The new version of the PCB is used inside the following the Han 3A RJ45 Hybrid panel feed through sets:

- 09 45 225 1300 (plastic version)
- 10 12 005 1004 (metal version)
- 09 45 545 1133 (PCB as spare part)

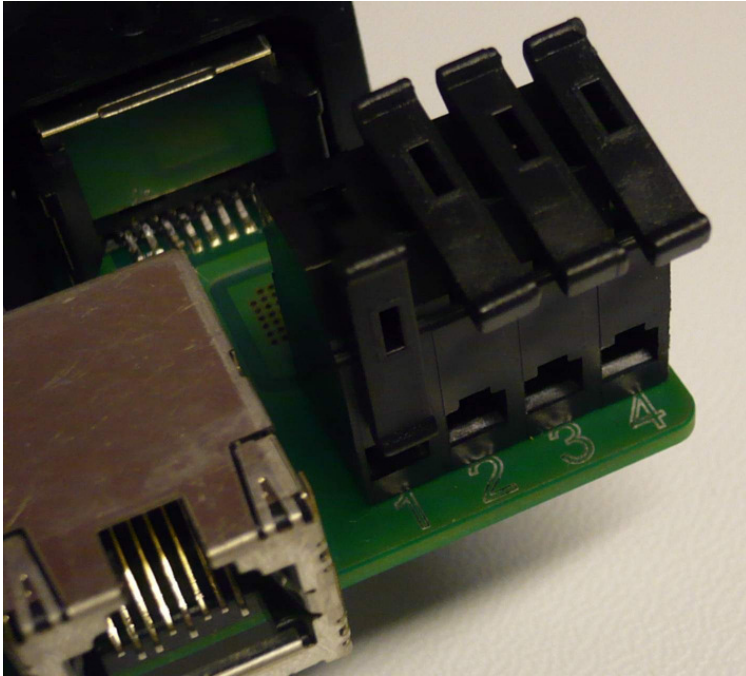
old version of 0945 225 1300

new version of 0945 225 1300

The new version has the following advantages compared with the old version:

- Reduction of the dimension of the PCB inside the switch cabinet
- No sharp edges at the PCB
- Very easy connection of the power wires with new type of screws less PCB terminal with reduced handling force to open and close the cage clamps at the terminal
- Better marking of the power terminals

Detail: new PCB terminal for power connection – low handling force and tool-less connection terminal and better marking of the terminals
